SEWAGE DISPOSAL SYSTEM

DEPARTMENT OF HEALTH AND MENTAL HYGIENE

SUBDIVISION Lisbon Acres LOT 24 ROAD 1224 Roundgate Terrace

REPAIR - PURPOSE - Voluntary upgrade of septic system. 10-4-99

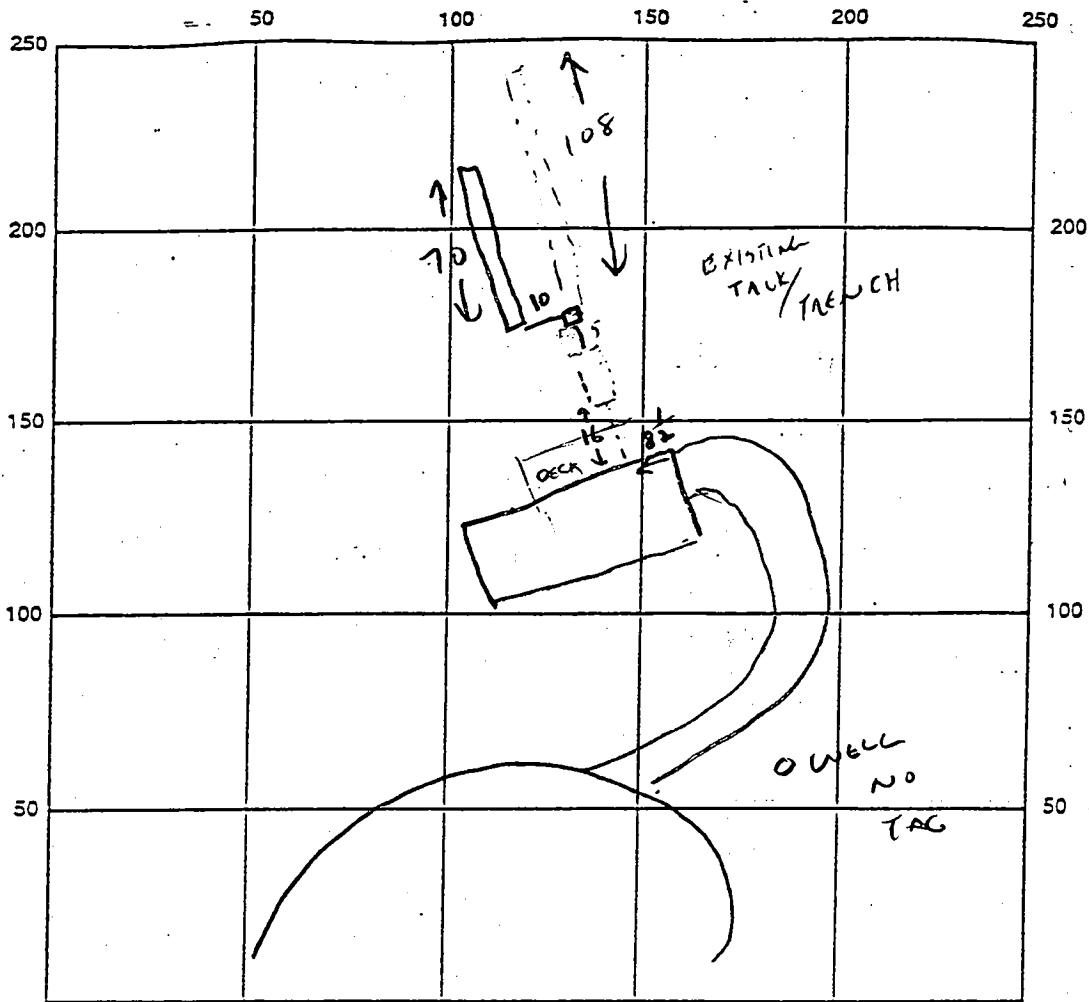
Please call for inspection when ground is opened so sanitarian can recommend repair.

OK TO INSTALL SHALLOW TRENCH IN PLATTED SEWAGE DISPOSAL AREA,  
10/28/99  
CW

REMARKS: 70' OF TRENCH ADDING TO EXISTING SYSTEM. C20666

ORIGINAL 108' TRENCH REMAINS IN SERVICE; PROPOSED

ORGANIC BUILDUP IN GRAVEL BUT NOT NOTICEABLY PONDING. 10/29/99 CW
